**DEPARTMENT OF ENVIRONMENTAL QUALITY
AIR QUALITY DIVISION
ACTIVITY REPORT: On-site Inspection**

FACILITY: Hound Resources - Wexford 10 Facility		SRN / ID: B5588
LOCATION: 7 Mile Rd., BUCKLEY		DISTRICT: Cadillac
CITY: BUCKLEY		COUNTY: WEXFORD
CONTACT: Julie Johnston , Vice President		ACTIVITY DATE: 07/24/2024
STAFF: Tammie Puite	COMPLIANCE STATUS: Non Compliance	SOURCE CLASS: SM OPT OUT
SUBJECT: Complete a Full Compliance Evaluation and Inspection for the Wexford 10 Facility.		
RESOLVED COMPLAINTS:

COMPLIANCE EVALUATION**PTI 140-22**

Image 4(NGL Tank) : Shows Secondary containment 1/2 full of water.

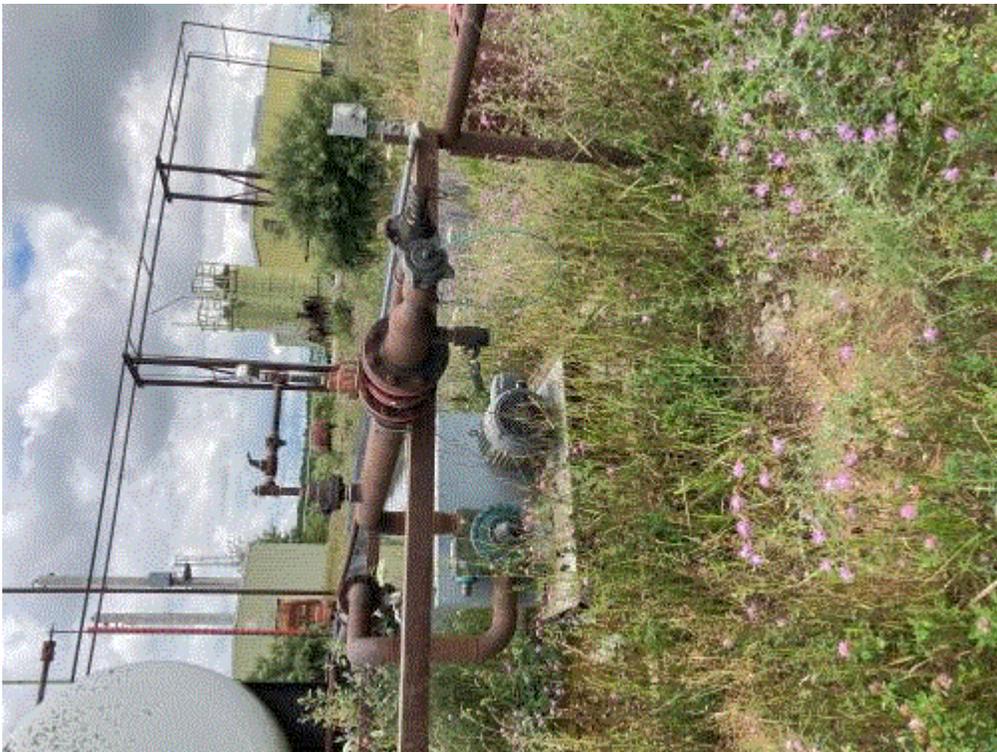
Image 1(EUDEHY) : Showing Leak

Image 2(Engine Stack) : Shows Stack Venting out Wall

Image 3(Sponges) : Shows that one of them is not operating.

Image 6(400 BBL Tank) : Overgrown Vegetation limiting Access to Tank.

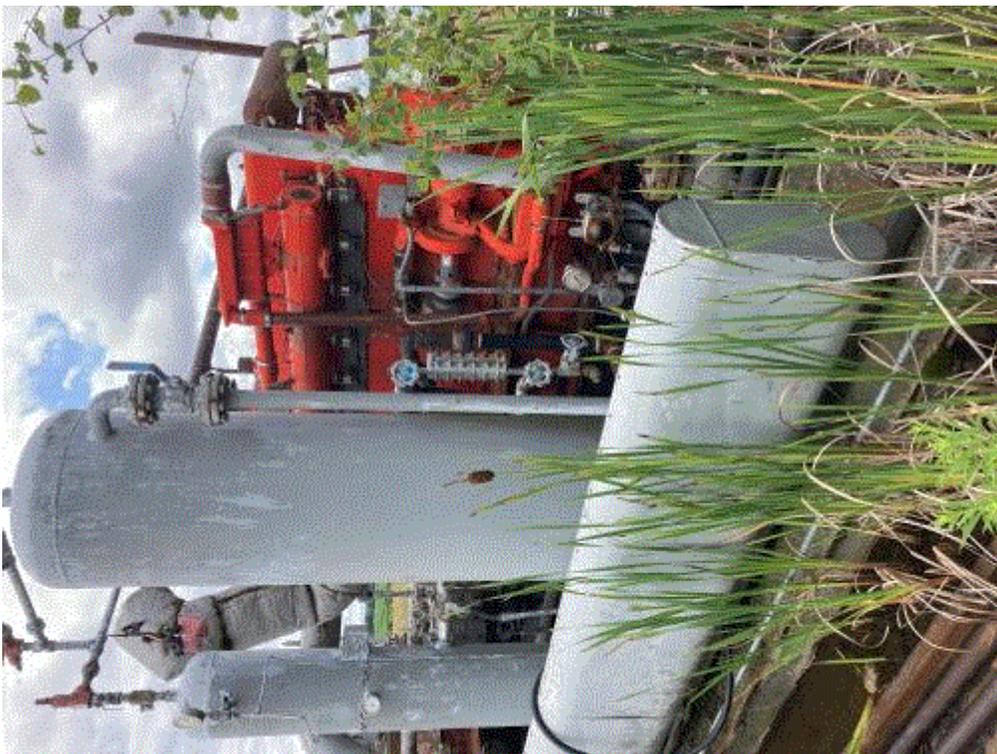
Image 5(NGI Tank Loadout) : NGL Loadout with excessive vegetation.

Image 11(EUDEHY) : Operating Dehy

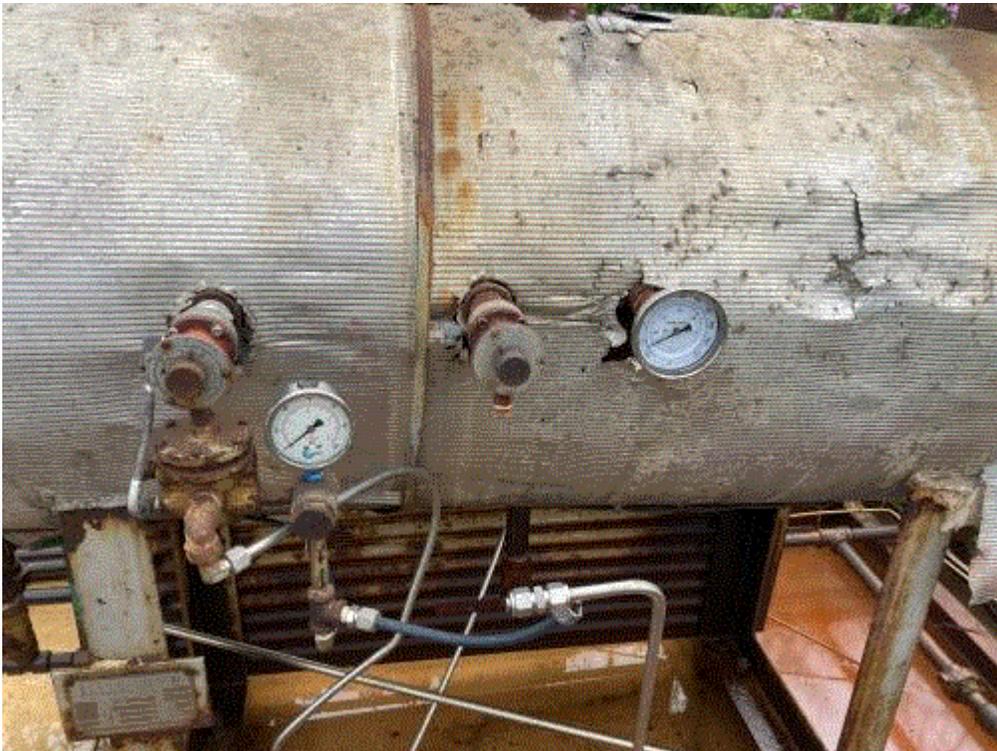
Image 7(Refrigeration Skid) : 6 Cylinder Waukesha Engine

Image 8(EUFLARE) : Operating Flare

Image 9(Old Compressor Eng) : 12 Cylinder Waukesha Engine - Not in Operation.

Image 10(BATB28) : Operating Engine

Image 12(EUDEHY) : Showing Reboiler not working

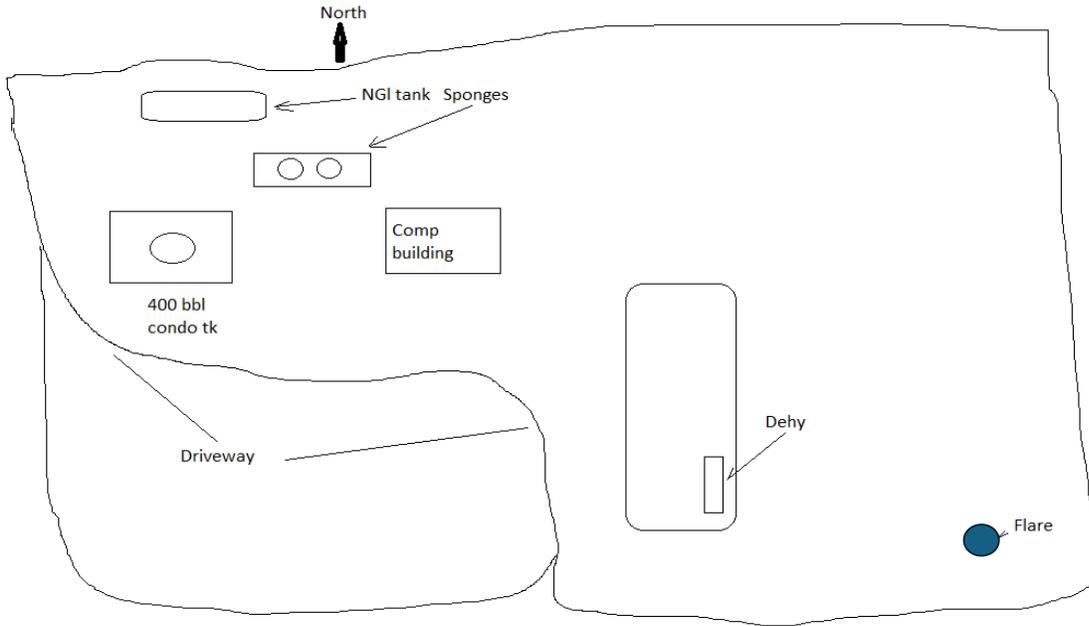
30,000 gal
NGL Tank

Leaking Compressor

Sponges - Only
1 working

Refrigeration Skid - Gas
was flowing through (NA)

Flare - Working
